Subject: NRC 10 CFR 71 Certificate of Compliance No. 9261, TAC L22085
License Amendment Request 9261-1

In support of the issuance of Revision 1 to 10CFR Part 71 Certificate of Compliance 9261 for the HI-STAR 100 transportation package, enclosed please find replacement pages comprising Revision 9 to the Safety Analysis Report (SAR). SAR Revision 9 reflects those proposed changes included in Reference 2 including a complete set of certificate drawings containing an appropriate level of detail for a transportation package.

Enclosure: Replacement pages for HI-STAR 100 SAR, Revision 9

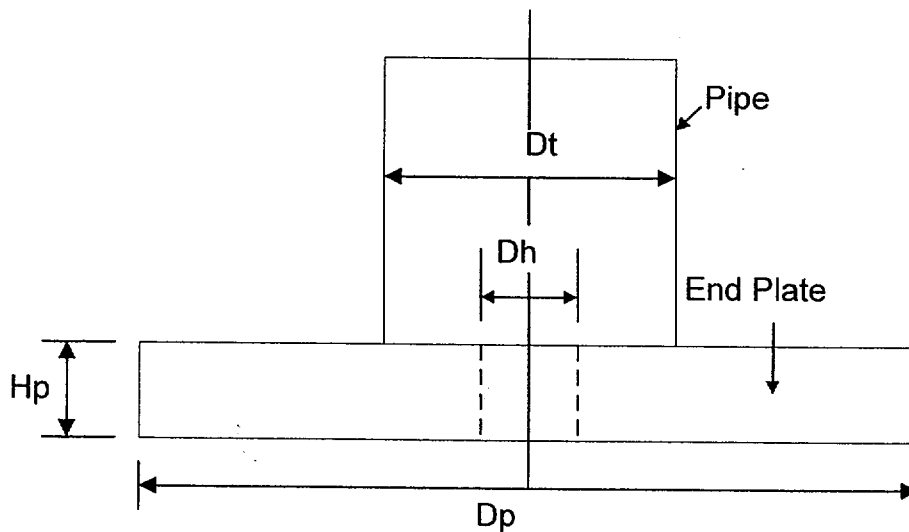
- e. Appendix 2.L is revised to reflect the reduction in closure ring weld size to 1/8 inch.
- f. Appendix 2.O is revised to include calculations to demonstrate the adequacy of the modification to the upper fuel spacer design to accommodate certain PWR fuel assemblies (see Attachment 4, Drawing C1396, Sheet 6)

The bending stress evaluation of the closure ring conservatively assumes a simple support condition exists at the peripheral welds. The associated stress at the weld line is a radially symmetric primary shear stress that is well within Code limits if a 0.125" (min.) weld is utilized.

FIGURE 5.3.9; HI-STAR 100 OVERPACK WITH MPC-24 CROSS SECTIONAL VIEW SHOWING THE THICKNESS OF THE MPC SHELL AND OVERPACK AS MODELED IN MCNP

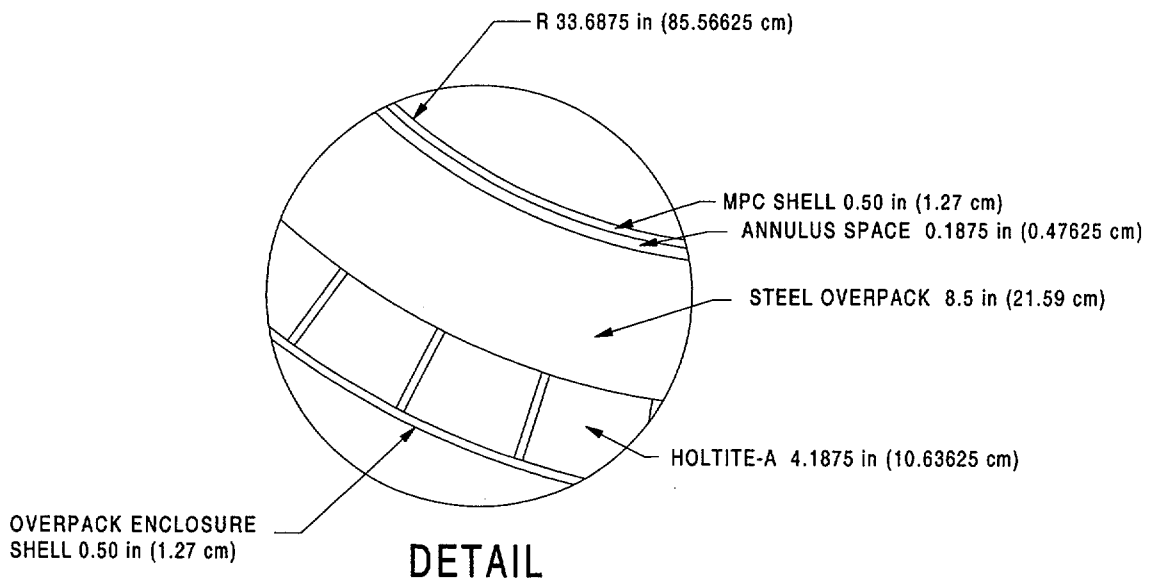
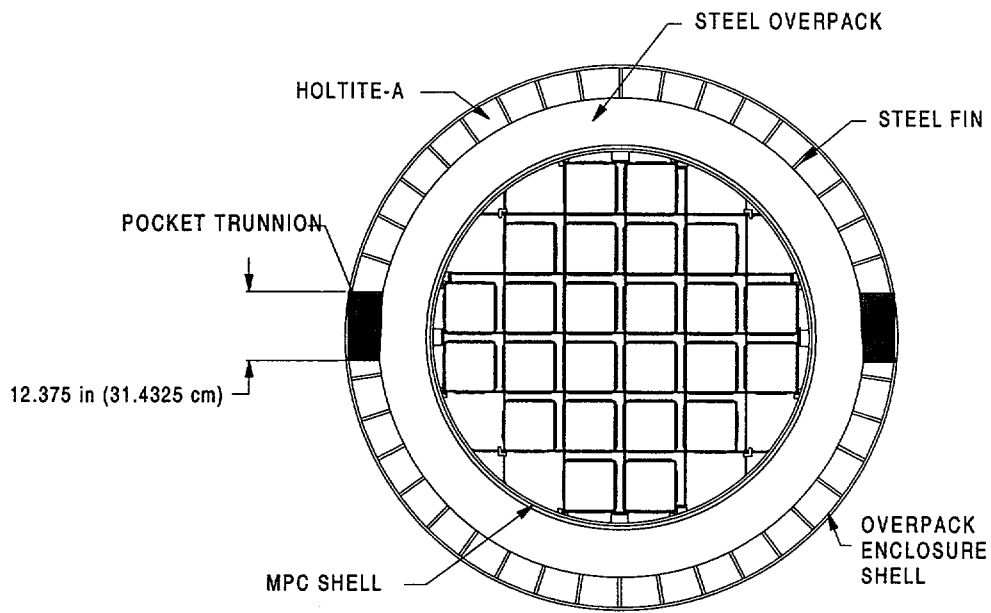
- k. Figure 5.3.9 is revised to correct a typographical error.
- l. New Subsection 5.4.5 is added to discuss the source terms for the Dresden Unit 1 antimony-beryllium neutron sources which are being added to the allowable contents for the HI-STAR 100 package.
